MEMO FROM COUNCIL OFFICE:

Re: Ordinance 2024-07 - To Amend the City of Bloomington Zoning Maps by Rezoning A 138.51 Acre Property From Planned Unit Development (PUD) And Residential Medium Lot (R2) to Planned Unit Development (PUD) And to Approve a District Ordinance and Preliminary Plan – Re: S. Weimer Road (Sudbury Partners LLC, Petitioner)

**TO AMEND THE CITY OF BLOOMINGTON ZONING MAPS BY REZONING A 138.51 ACRE PROPERTY FROM PLANNED UNIT DEVELOPMENT (PUD) AND RESIDENTIAL MEDIUM LOT (R2) TO PLANNED UNIT DEVELOPMENT (PUD) AND TO APPROVE A DISTRICT ORDINANCE AND PRELIMINARY PLAN
- Re: S. Weimer Road
(Sudbury Partners LLC, Petitioner)**

2. ELECTRIC VEHICLE PARKING CHARGING STATIONS

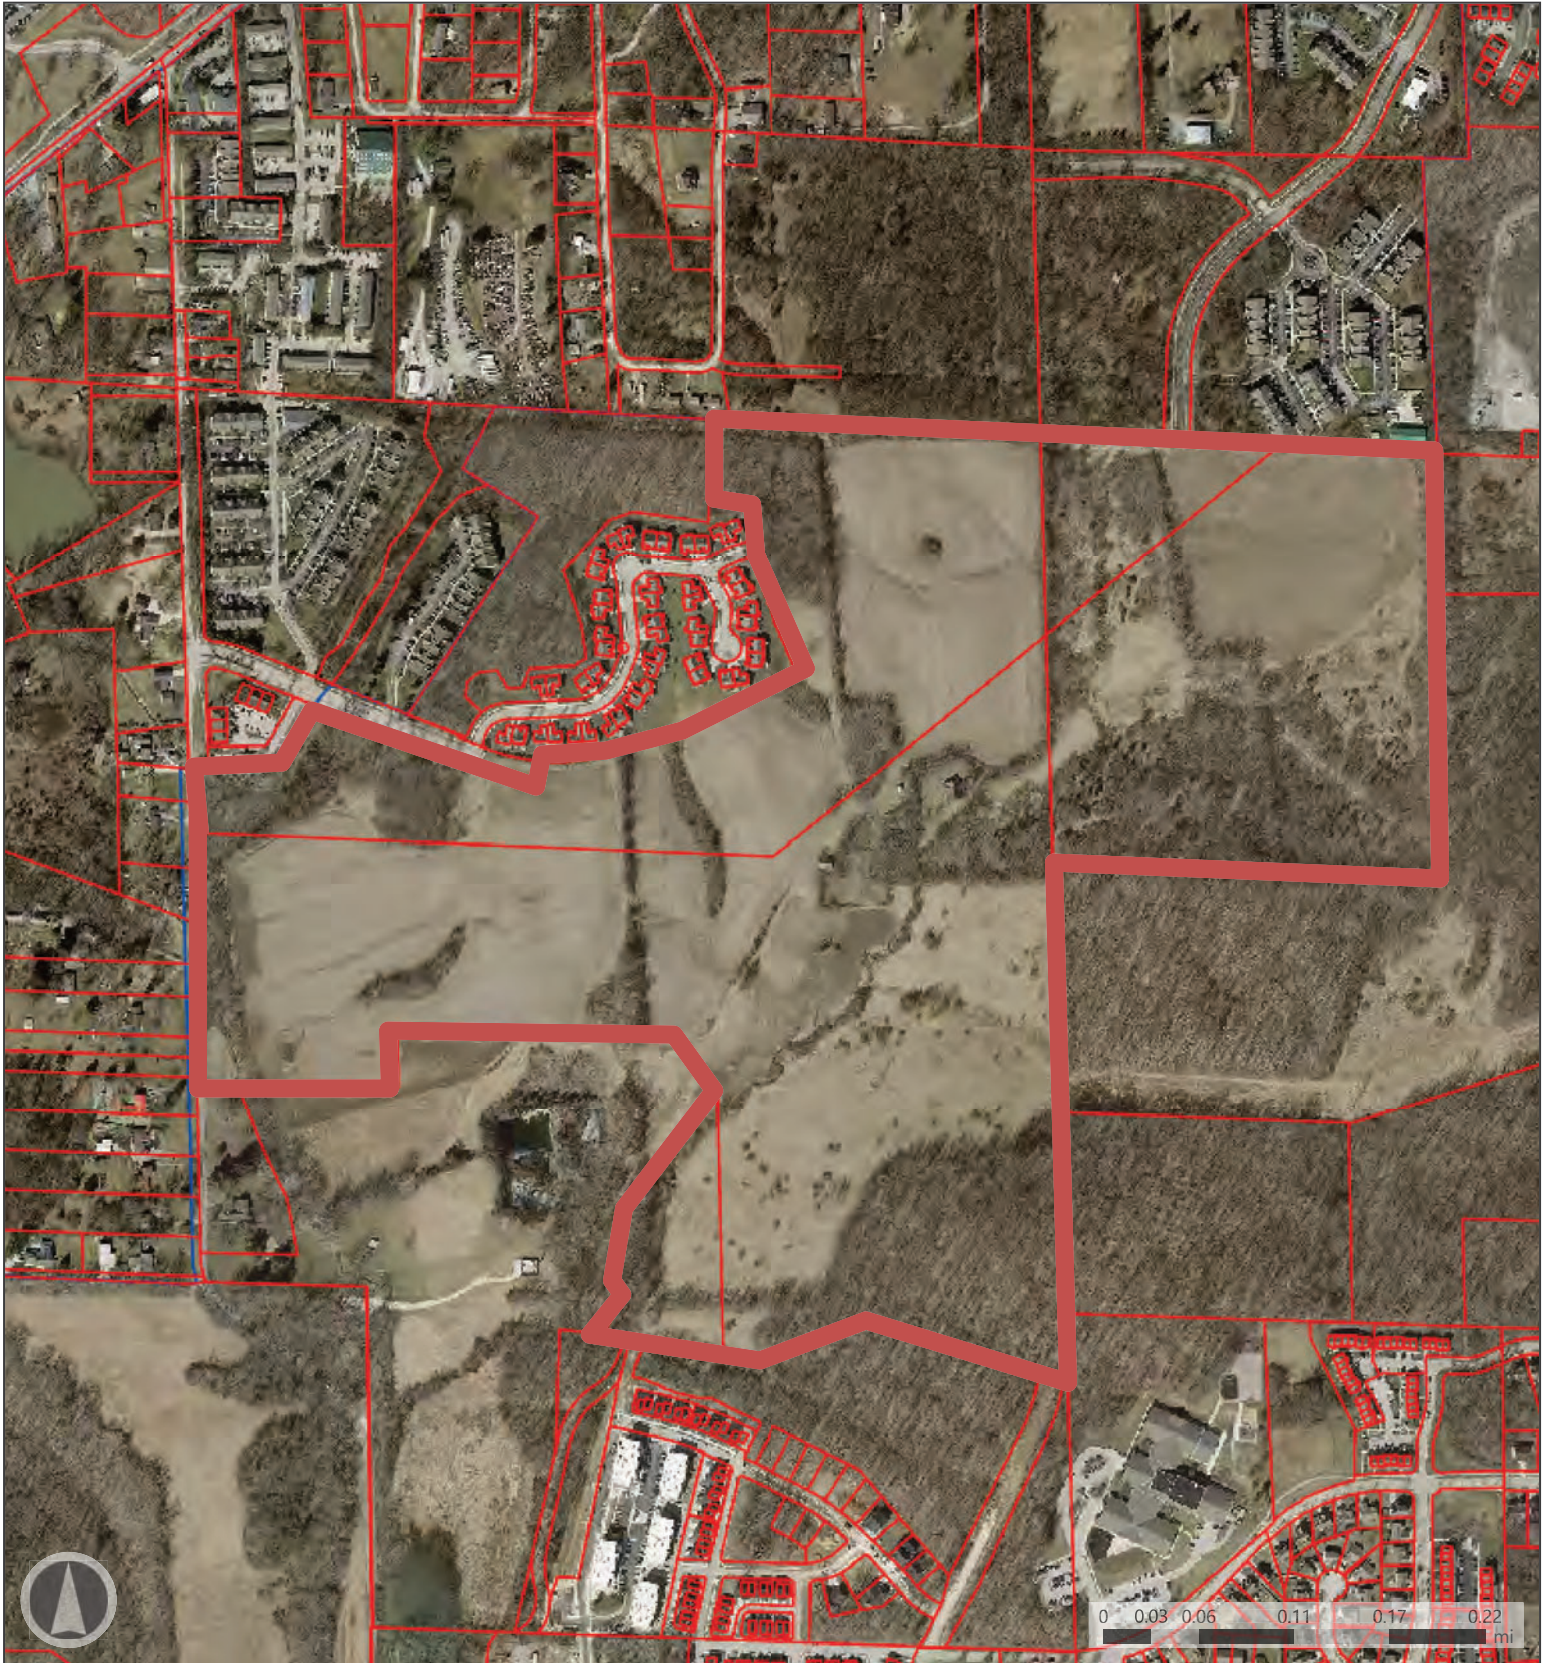
Even though the Petitioner proposes the same number of electric vehicle (EV) parking sites as required by the UDO, the EC believes they need more. Instead of two EV spaces per fifty regular spaces, the EC suggests four EV spaces per fifty regular spaces.

FIGURE District 11: Area Map

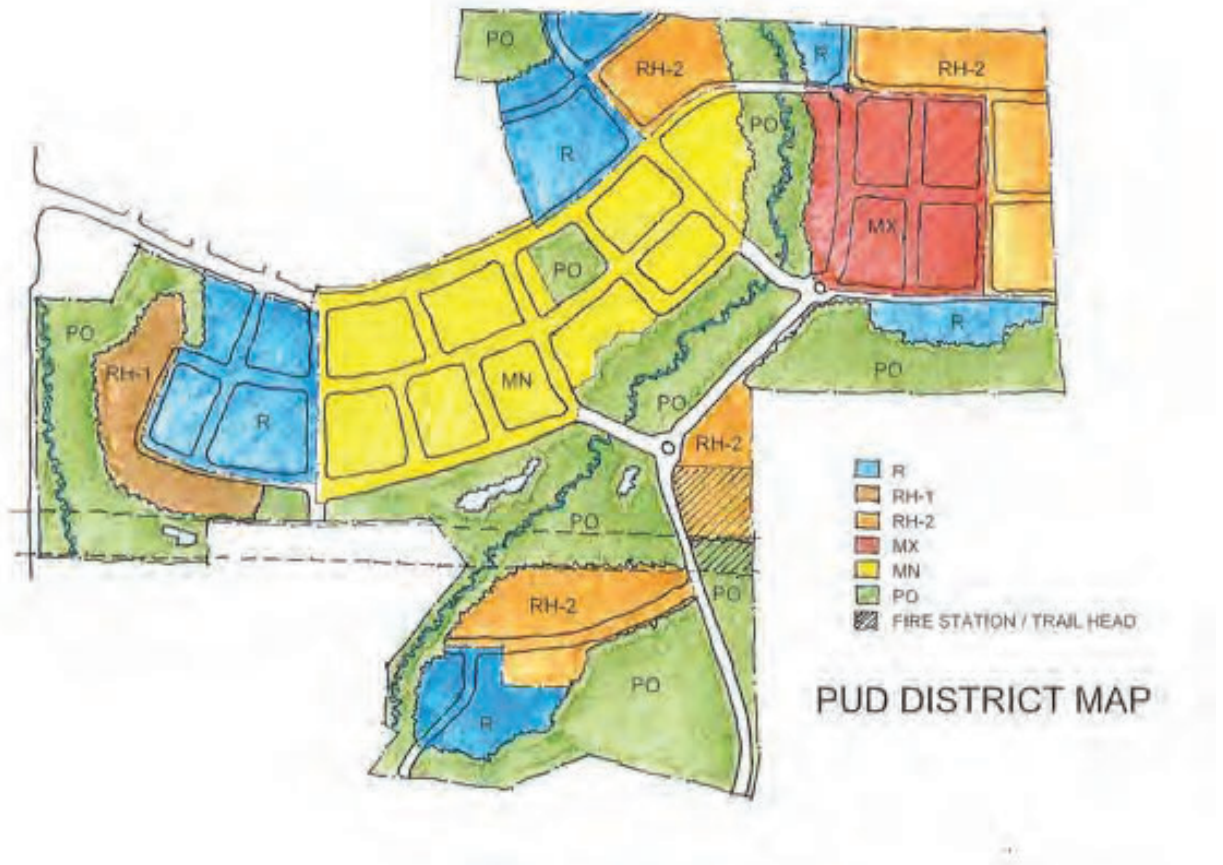
The PUD DO, page 19 in Figure 12 shows that all three residential districts are allowed up to 70% impervious surface coverage, and 90% and 95% for the mixed use. The PO district is allowed 10% impervious surface despite supposedly being preserved land. The EC opposes this. Although Bloomington and the EC focus on density, the EC believes that these amounts of impervious surface coverage are too dense for good quality of life and environmental ecosystem services.

Figure 12, page 19, shows that there are no minimum landscape size requirements for **any** of the 6 districts. Can the Petitioner please explain what this means? Additionally, with density and impervious surface coverage so high, it appears there is no way that UDO landscape rules will be able to apply.

Figure 1. Summit District PUD nearby streets. Red circles are anticipated choke points.

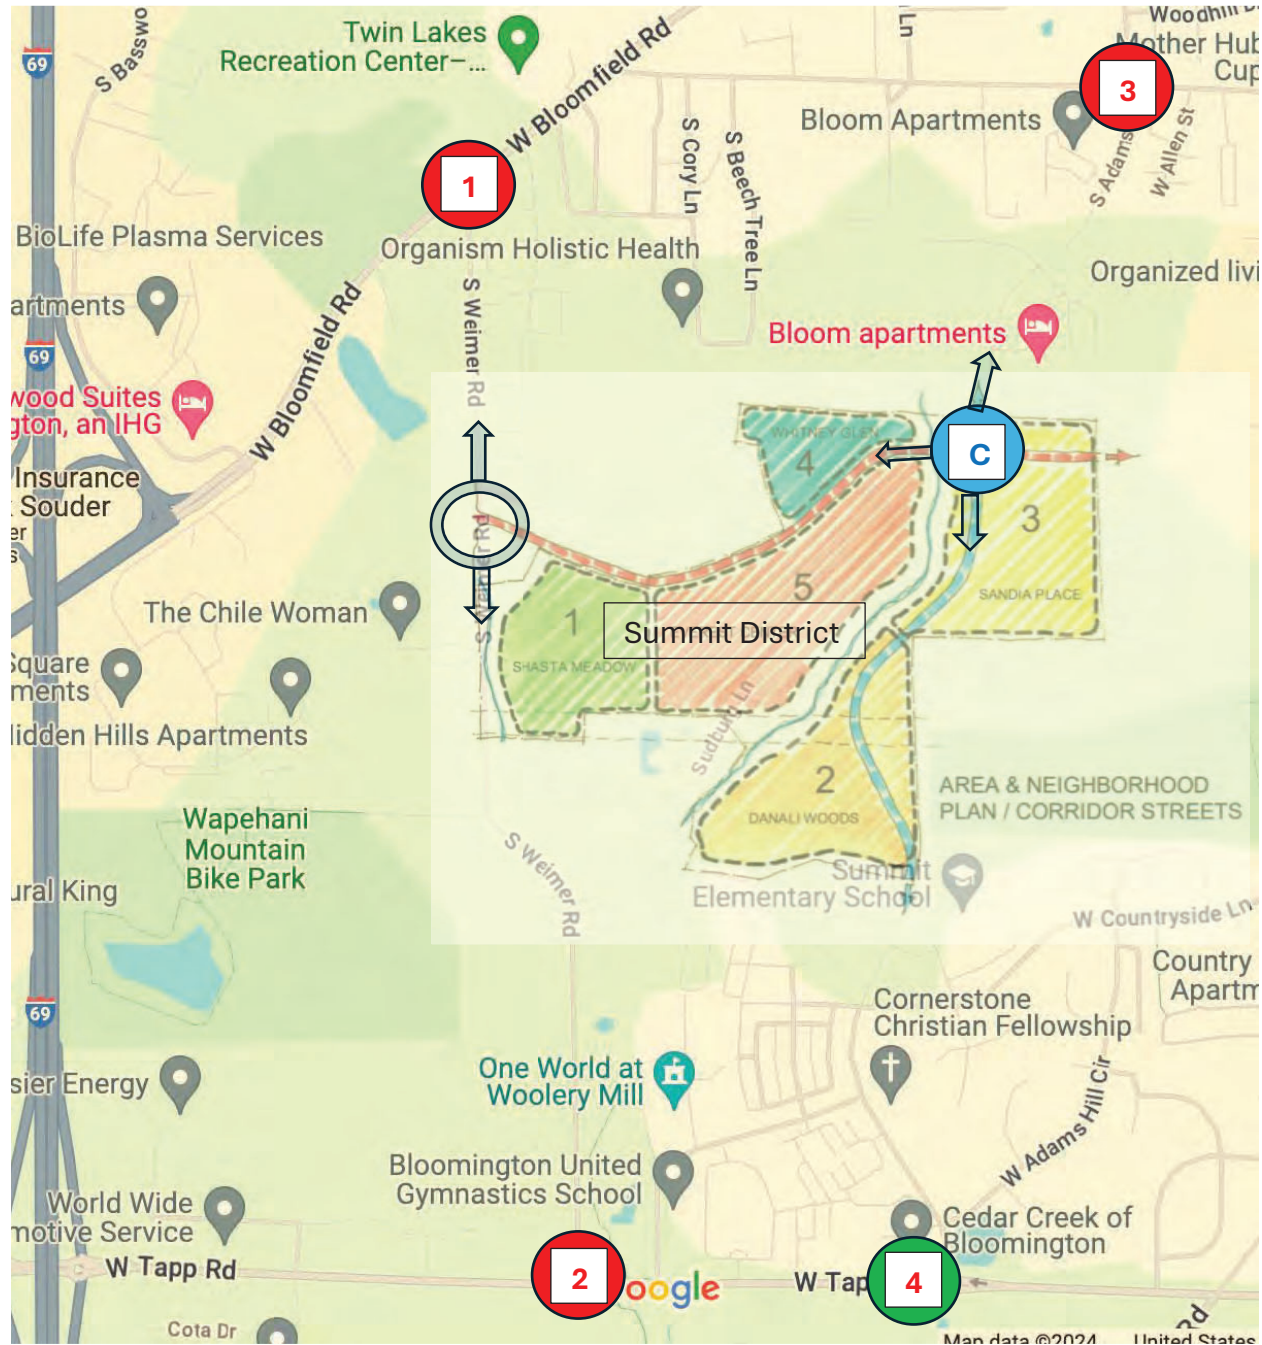
great as the city of Martinsville. While these are ballpark estimates, they do put things into perspective, as Table 1 shows. And this will impact traffic congestion, because currently there are only 4 main ways to get in or out of the Summit PUD area to nearby main arterials (Tapp Rd. and Bloomfield Rd.). Note that S. Adams intersects with W. 2nd St where there is currently a stoplight, which is north of the Adams and Allen St. intersection at circle 3.

Image A*. COBERI Figure 5 of karst areas in southwest Bloomington in 2003. Superimposed is Image One from the Bloomington Plan Commission staff report in the BPC meeting packet for Sept. 11, 2023.

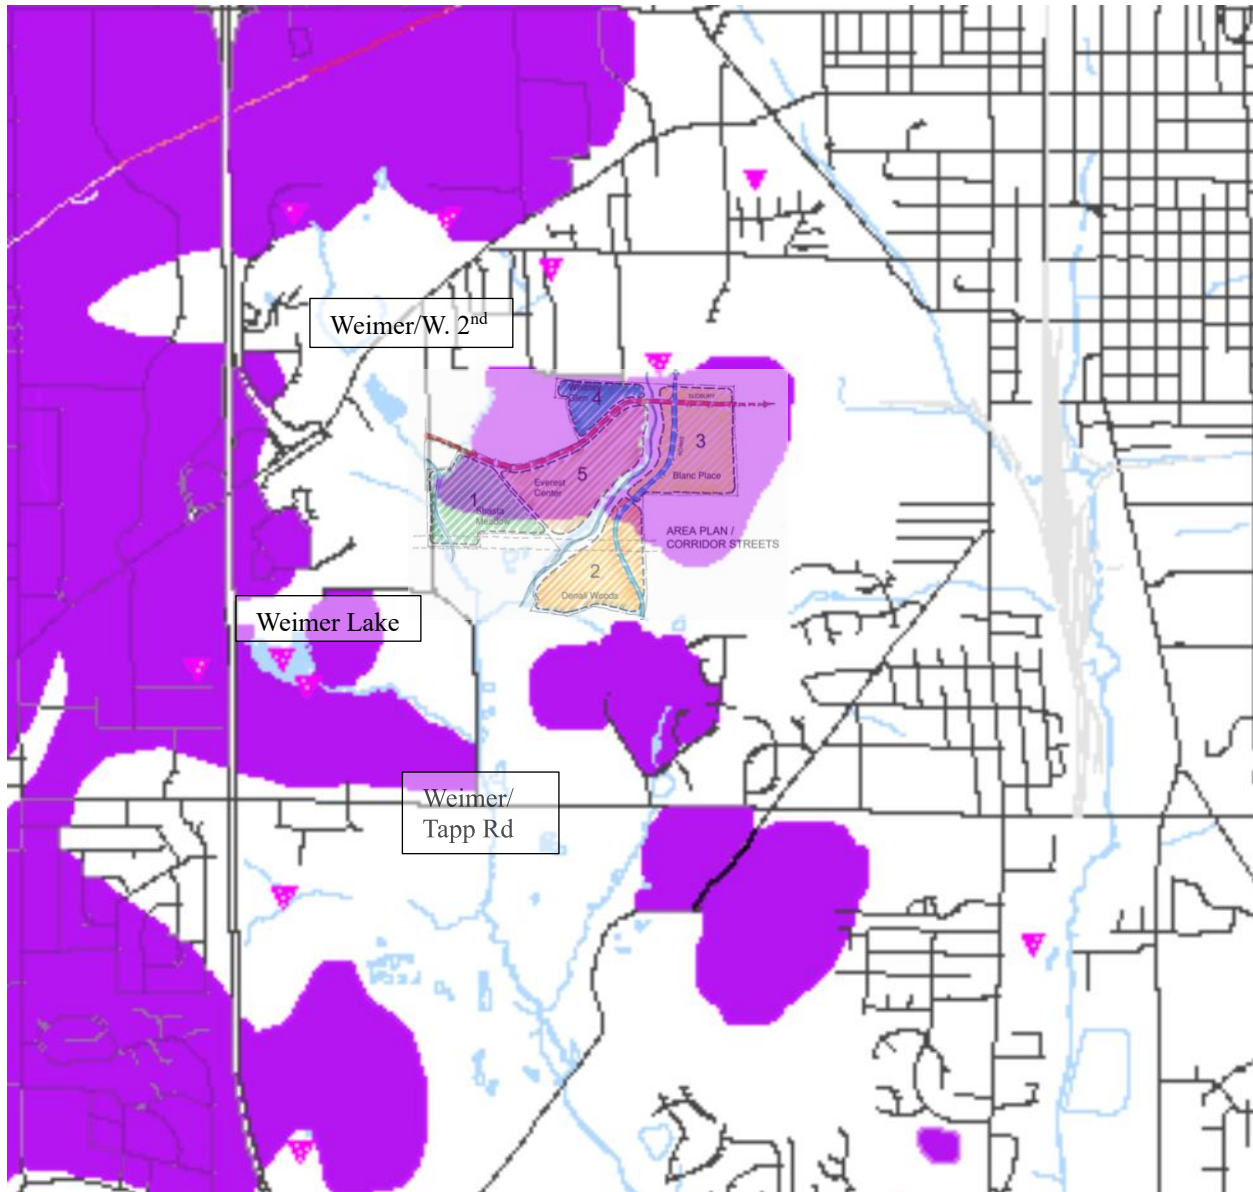
A number of sinkholes were reportedly located within the PUD, especially at the higher elevations of the Summit District. See Stantec's Environmental Constraints report in the BPC meeting packet: https://bloomington.in.gov/onboard/meetingFiles/download?meetingFile_id=13177. It is evident in map EX-8 (p. 107) that bedrock is typically 3 to 5 feet below the surface in much of the PUD area in the higher elevations, and Image A* indicates that this is mostly karst. Although the Summit District PUD indicates preservation and protection of 48 existing sinkholes identified in EX-8, **the fact remains that much of the development would be on top of or may need to cut into existing karst bedrock identified in the COBERI and Stantec reports.**
